**Sub: Construction of Jia Bharali Bridge along with its approaches and River Training Work from km 25.552 to km 27.500 of NH-37A (New NH-715) in the State of Assam on EPC Mode.**  
**Tender ID: 2020\_NHIDC\_579594\_1**

Replies for the queries raised during Pre-bid meeting				
Sl. No.	Section Cl. No./ Sub-Clause	Title	Queries from Bidders	Response by Employer
1	General	Condition of Exposure.	Condition of exposure is Moderate. Please confirm.	To be considered as per latest IRC Code pertaining to the subject after assessing the site conditions
2	General	Type of superstructure & Foundation	Bidder understand that type of superstructure, substructure and foundations can be altered / Change based on the design requirement as an EPC contract. Please confirm.	Design to be done by the EPC Contractor as per codal provisions. However, Design to be approved by the Authority's Engineer.
3	General	Span arrangement of Major Bridge	Bidder understand that Span arrangement of major bridge can be alter by keeping overall length same. Span 48.0m specify in drawing is not madetory and bidder can adopt larger span also. Please confirm.	Design to be done by the EPC Contractor as per codal provisions. Ho

TYPICAL CROSS SECTION TYPE A4

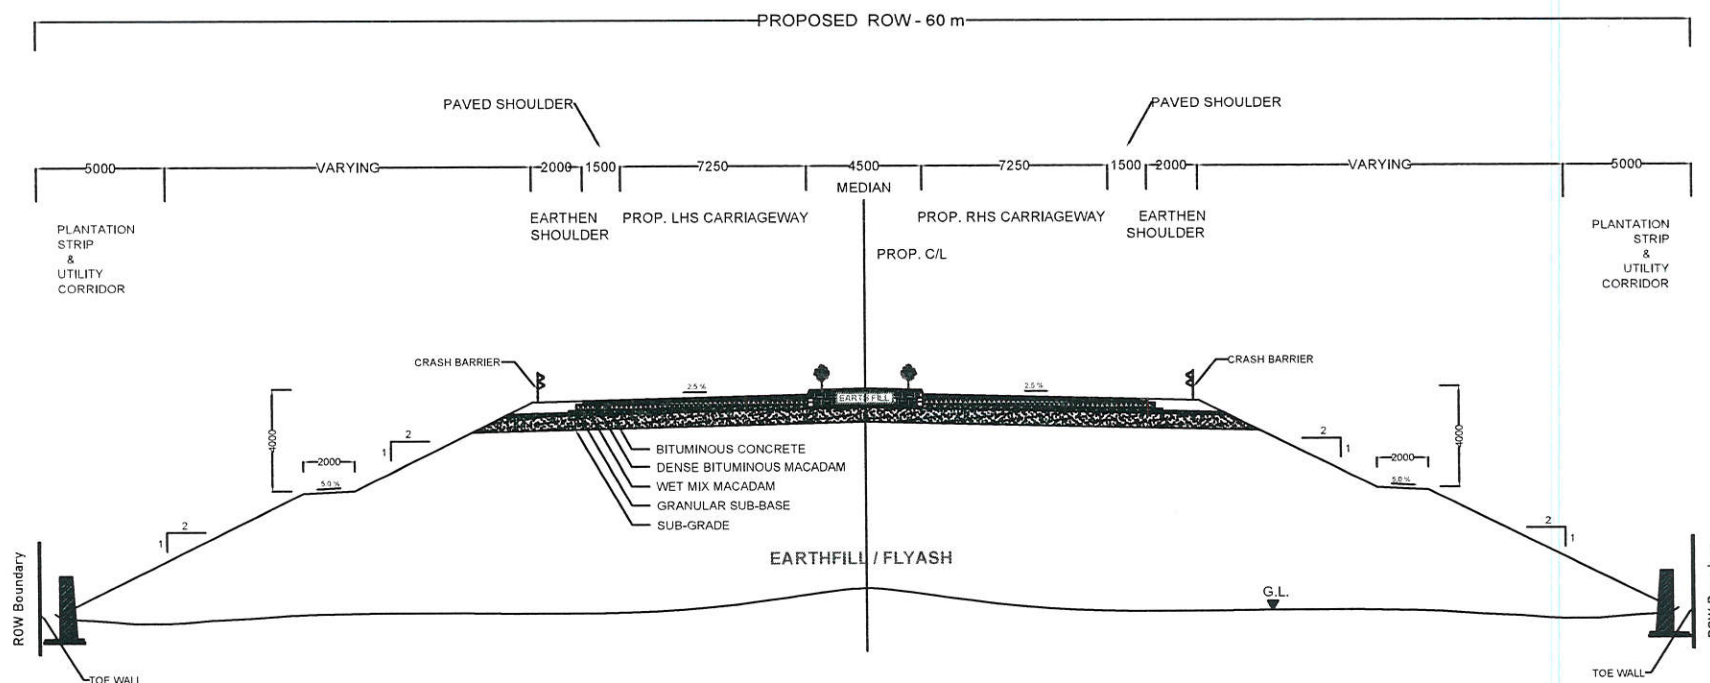
Requirement of DATA for Design of Major Bridge: (i) Bearing Capacity and Classification of Soil at Founding Level. (ii) Catchment Area (iii) HFL (iv) Velocity of Flow during HFL (v) Vertical (vi) Design / Maximum Depth of Scour (vii) Silt Factor (viii) Flood with Seismic Combination (ix) Low Water Level	
85			(x) Cross - Sections of the River in U/s and D/S (xi) Bed Slope of the River (xii) Particulars of Proposed Bridge - Width, Carriage Way, Class - 70R/AA/A (xiii) Flood Width (xiv) Topography (xv) Weather (xvi) Environment	Details provided are indicative and the bidder has to assess these details on its own.
86			Survey Details for Guide Bund, Y-Junction, River Training etc. and Bridge	
87			GPS coordinates of Bridge & River Training	
88			Silt content as in SSI	
89			Kindly provide SSI Report of the proposed Bridge.	
90			Overall width of Bridge, Footpath and Carriageway.	
91			Approach length and Cross section
